CONTRACT CHANGE ORDER NO. _____
SHEET ____ OF ____

MARK	DATE	DESCRIPTIONS	BY	CH'D	CCO#
2	02/01/11	PIER E2 CAPBEAM SAFETY CABLE	CC	AS	181
1	06/12/09	HANDRAIL	TH	AS	114

SAN FRANCISCO OAKLAND BAY BRIDGE
EAST SPAN SEISMIC SAFETY PROJECT
SELF-ANCHORED SUSPENSION BRIDGE
(SUPERSTRUCTURE & TOWER)

PIER E2 ACCESS DETAILS NO.1

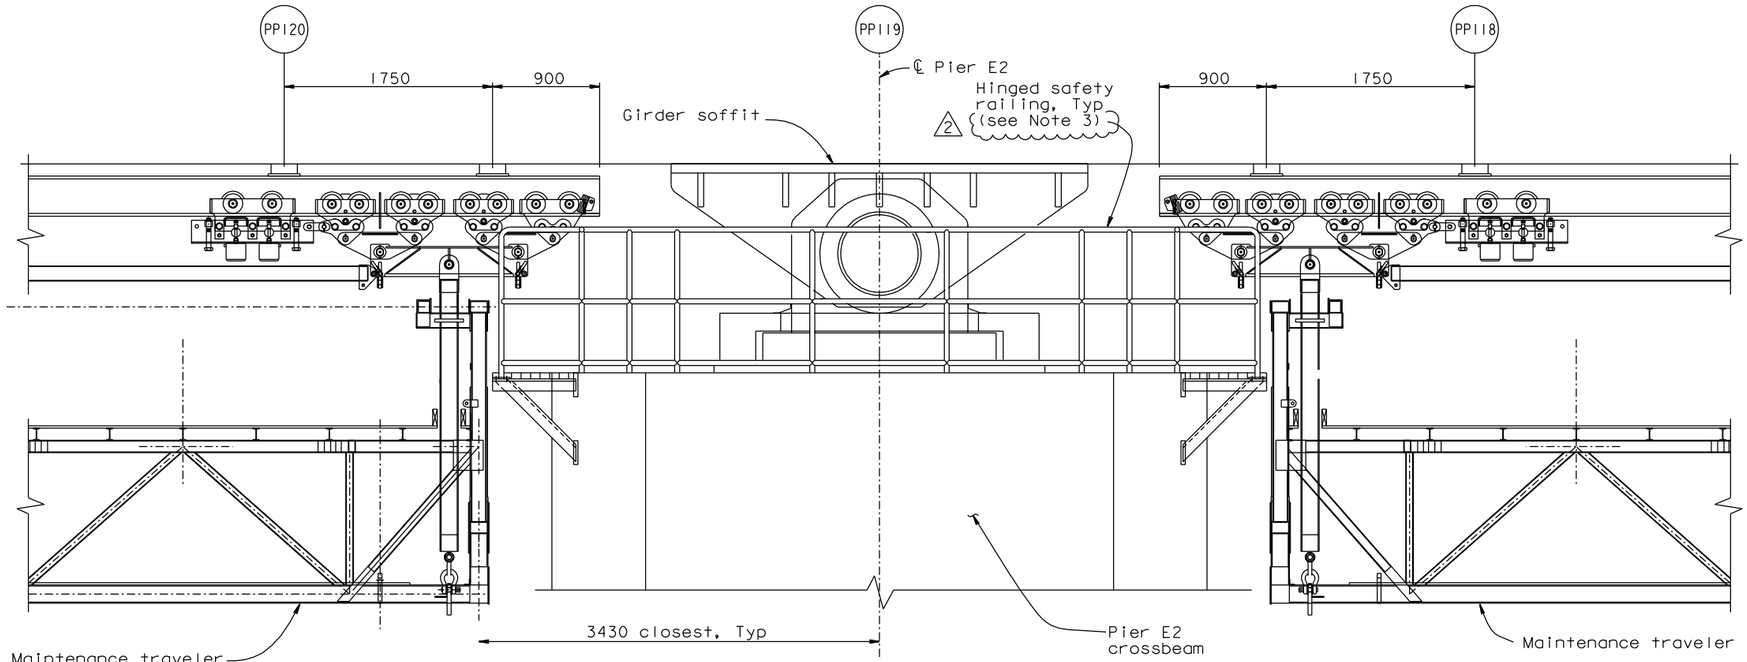
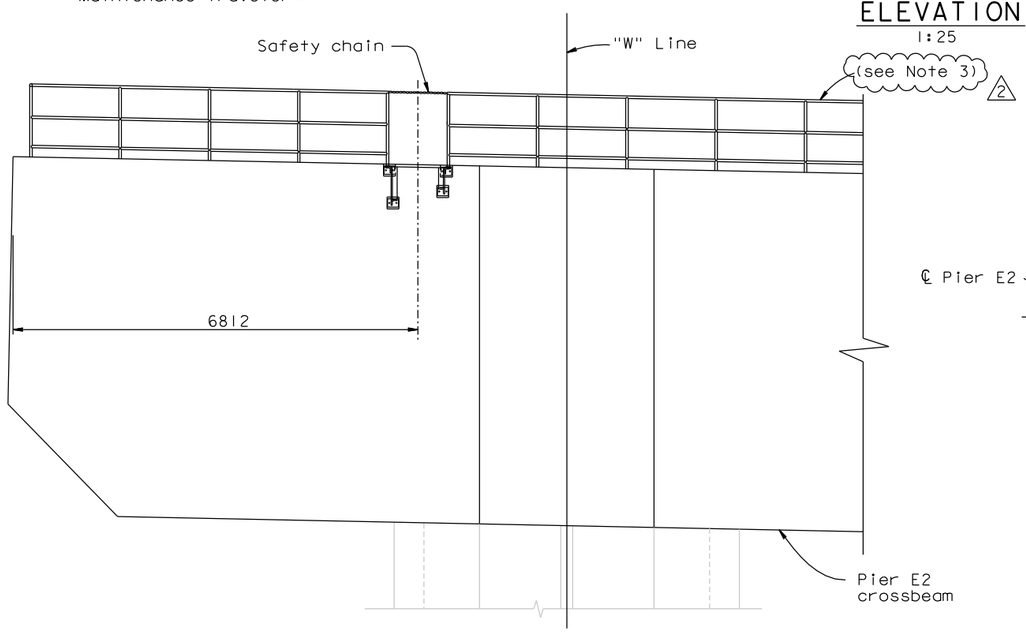
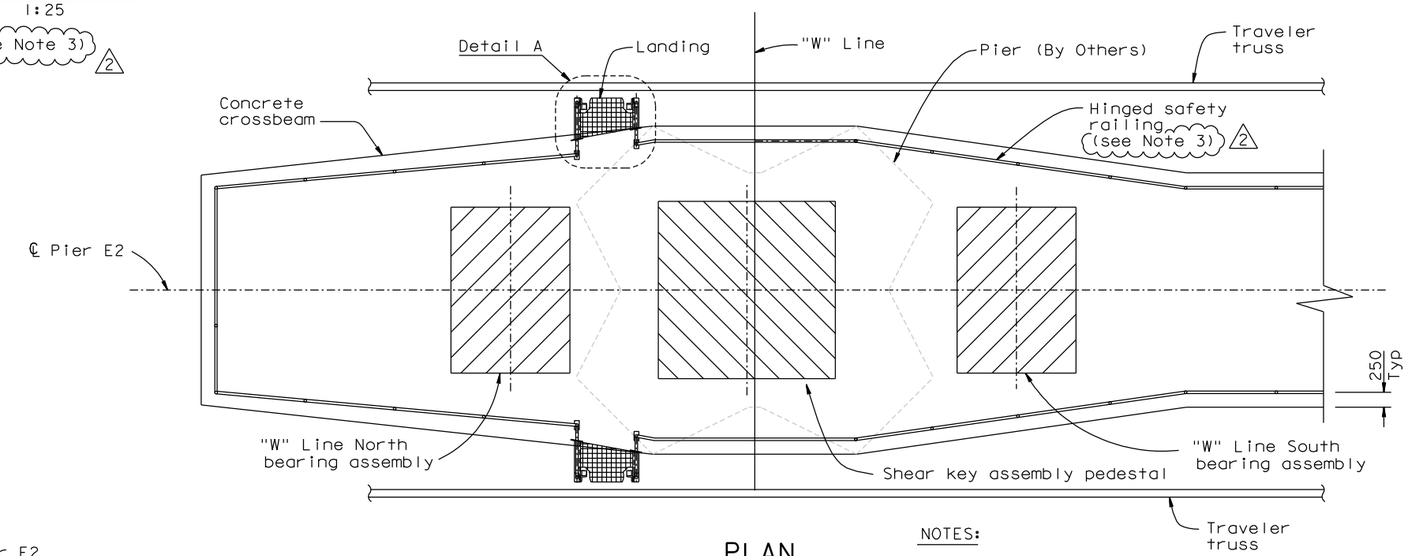
1. For Detail A, see "Pier E2 Access Details No.2" sheet.
2. For typical hinged safety railing details, see "Revised Standard Plan RSP S11" sheet.
3. (2) Pier E2 Capbeam Safety Cable Alternate Plan may be used, see "Pier E2 Access Details No.3" sheet.

PIER E2 CAPBEAM SAFETY CABLE ALTERNATE PLAN

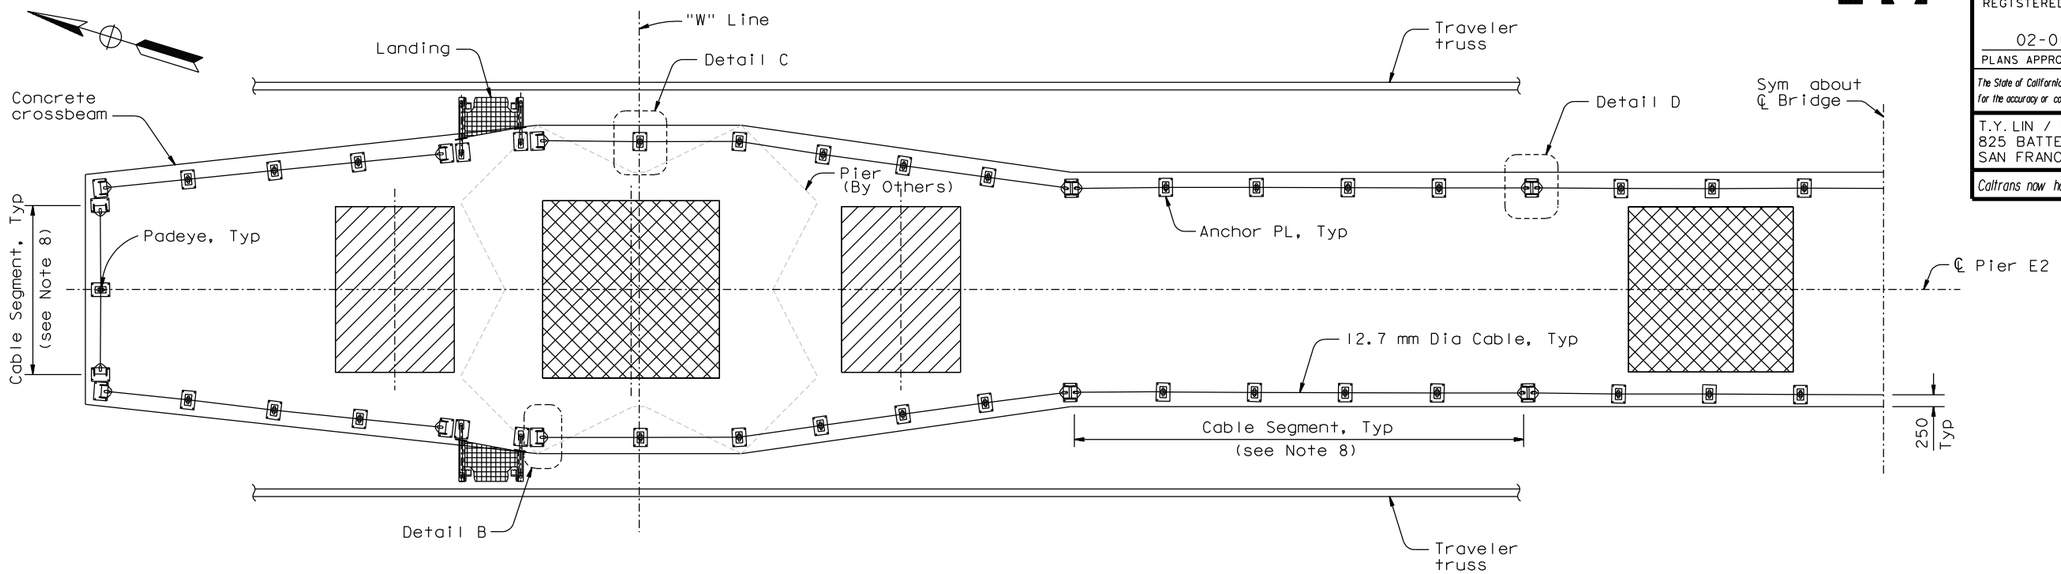
1. For details not shown, see "Pier E2 Access Details No. 1" sheet.
2. For Details B, C and D, see "Pier E2 Access Details No. 4" sheet.
3. The cable shall be RRL preformed wire rope, 6x19 Class, IWRC, XIP, with minimum breaking strength of 118.3 kN.
4. Cable shall not be spliced between terminations.
5. All cable and hardware to be galvanized and installed per manufacturer's recommendations.
6. Cable shall be installed with a deflection between 100 to 150 mm, measured from taut position, when pulled with an upward force of 0.13 kN at midpoint between any two padeyes.
7. The safety cable shall have a maximum use of two persons at one time between anchors.
8. For all cable segments, Contractor shall determine installation length by survey.

MARK	DATE	DESCRIPTIONS	BY	CH'D	CCO#
0	02/01/11	PIER E2 CAPBEAM SAFETY CABLE	CC	MN	181

PIER E2 ACCESS DETAILS NO. 4

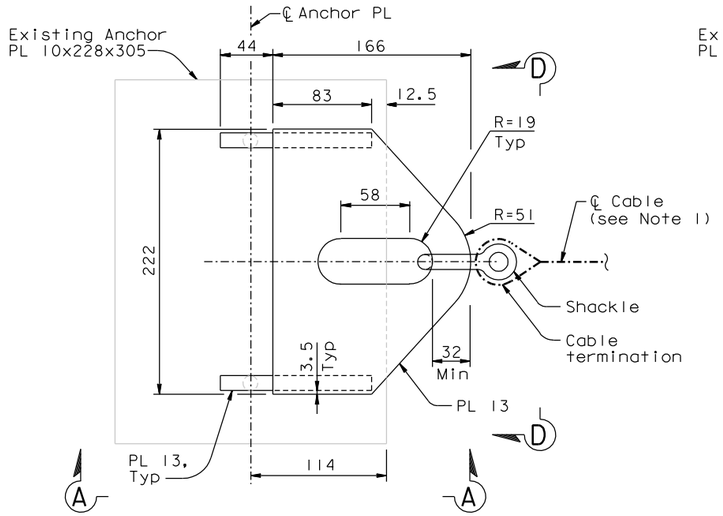
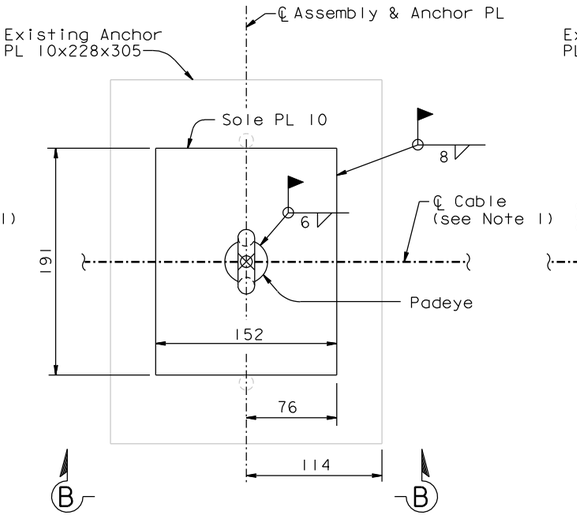
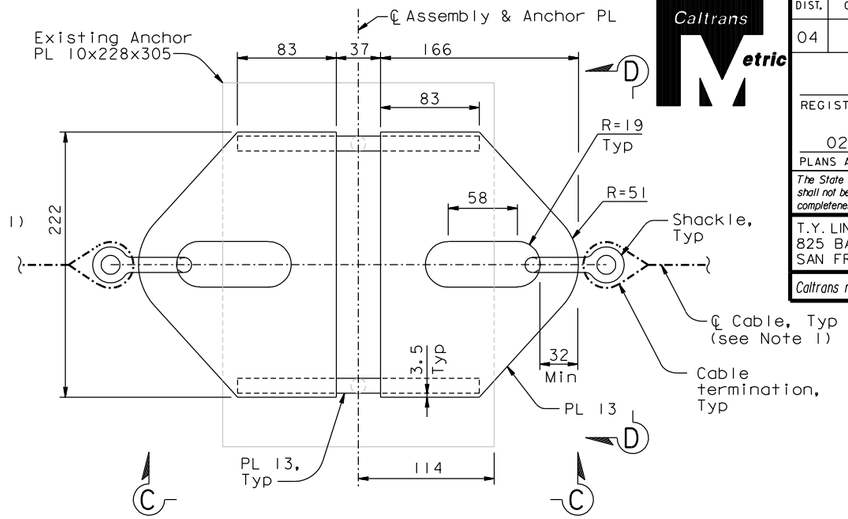
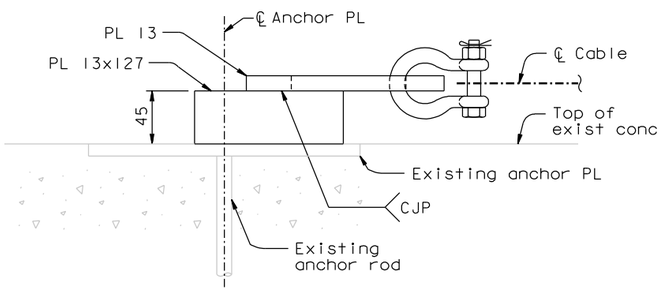
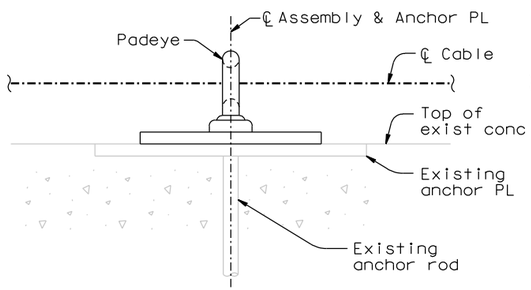
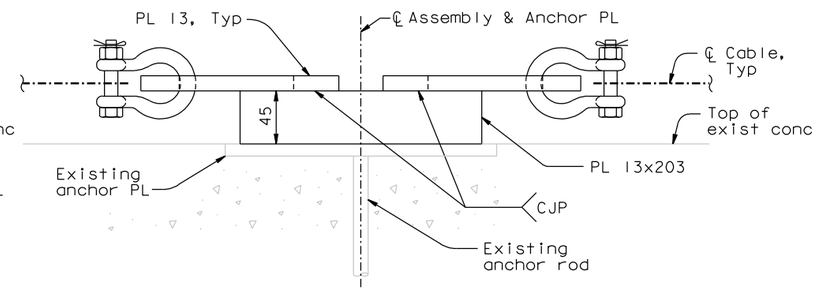
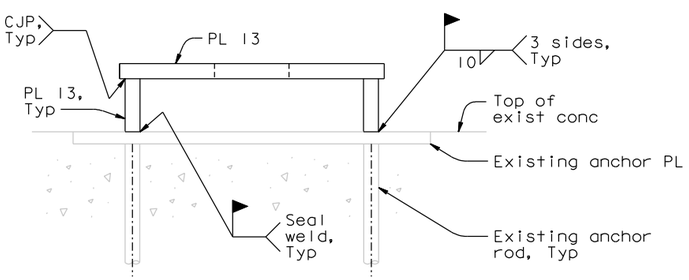
1. For layout of cable, see "Pier E2 Access Details No. 1" sheet.
2. Provide thimbles at all cable loops per manufacturer's recommendation.
3. Padeye shall be Crosby size No. 5 or equivalent.
4. Sole plates and anchor plates shall have a minimum yield strength of Fy=50 ksi (345 MPa) and shall be A572 or equivalent.
5. Shackle shall be 0.5 in (12.7 mm) Crosby bolt type anchor shackle or equivalent, with a working load limit of at least 2 metric tons (19.6kN). Shackle shall be galvanized.

MARK	DATE	DESCRIPTIONS	BY	CH'D	CCO#
0	02/01/11	PIER E2 CAPBEAM SAFETY CABLE	CC	MN	181
